New CTP Replacement Parts for Caterpillar® Equipment

# CTP GLOW PLUGS

## NEW IMPROVED

## Cross Section

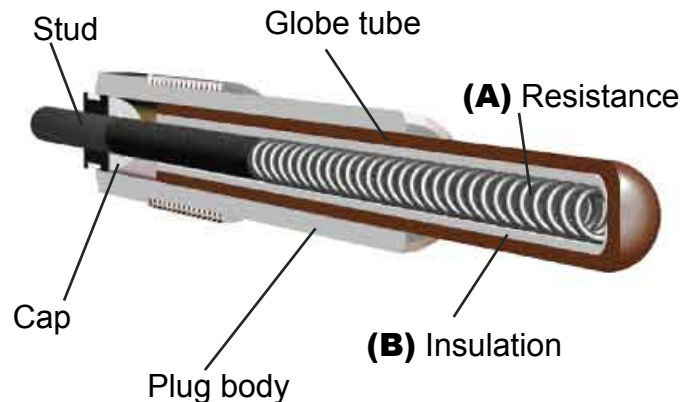
**Internal resistance's re-design and material change (A):** produces a higher durability, and the supporting of unexpected over-tensions.

**The addition of an internal insulating**

**material between the resistance and the tube (B):** provides a better insulation control, with a lower internal humidity retention, generating a longer life for heater element
